**Economic Commission for Europe****Inland Transport Committee****World Forum for Harmonization of Vehicle Regulations****Working Party on Passive Safety****Sixty-third session**

Geneva, 14-18 May 2018

**UN Regulation No. 29 (Cabs of commercial vehicles)****Proposal for Supplement 4 to the 03 series of amendments to  
UN Regulation No. 29 (Cabs of commercial vehicles)****Submitted by the expert from Germany\***

**Figure 1**  
**Front impact test and front pillars impact test**  
**The cab is mounted on the vehicle**

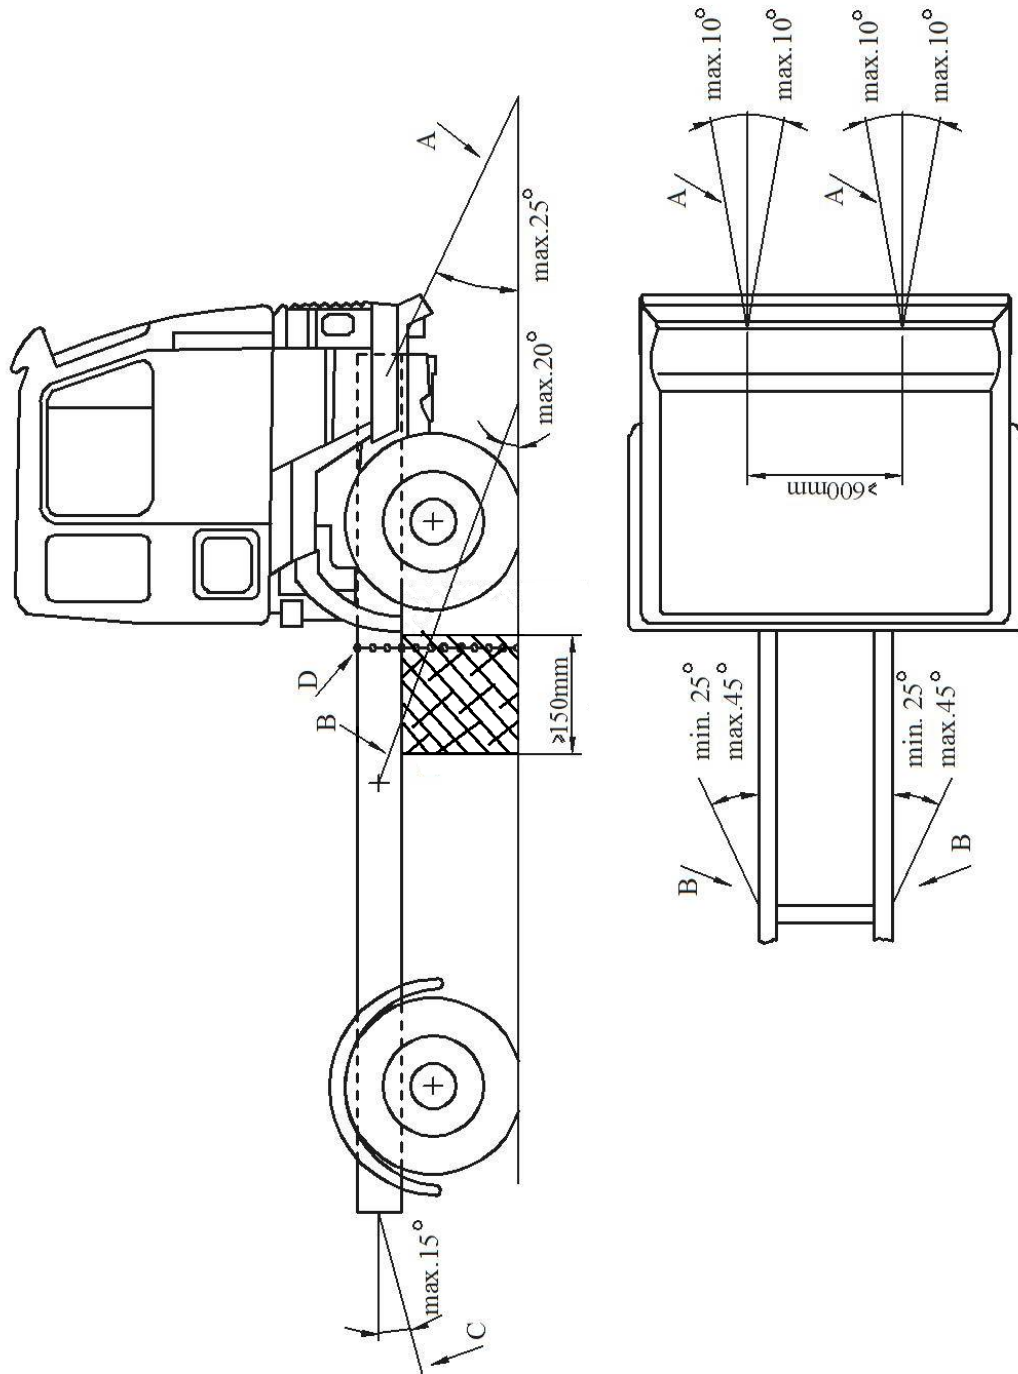
Rearward movement of the chassis frame shall be limited by chains or ropes A attached to the front of the chassis frame symmetrically in relation to its longitudinal axis, the points of attachment being not less than 600 mm apart. The chains or ropes shall when tensioned form a downward angle of not more than 25° with the horizontal and their projection on a horizontal plane shall form an angle of not more than 10° with the longitudinal axis of the vehicle (**see figure 1 below**). The chains or ropes may cross one another.

**Lateral movement shall be limited by chains or ropes B attached to the chassis frame symmetrically in relation to its longitudinal axis. The points of attachment to the chassis shall be not more than 5 m and not less than 3 m from the front of the vehicle. The chains or ropes shall when tensioned form a downward angle of not more than 20° with the horizontal and their projection on a horizontal plane shall form an angle of not less than 25° and not more than 45° with the longitudinal axis of the vehicle (see figure 1 below).**

when tensioned form a downward angle of not more than 20° with the horizontal and their projection on a horizontal plane shall form an angle of not less than 25° and not more than 45° with the longitudinal axis of the vehicle (see figure 1 below).

Figure 1, shall be deleted

Insert new Figures 1 and 2, to read:
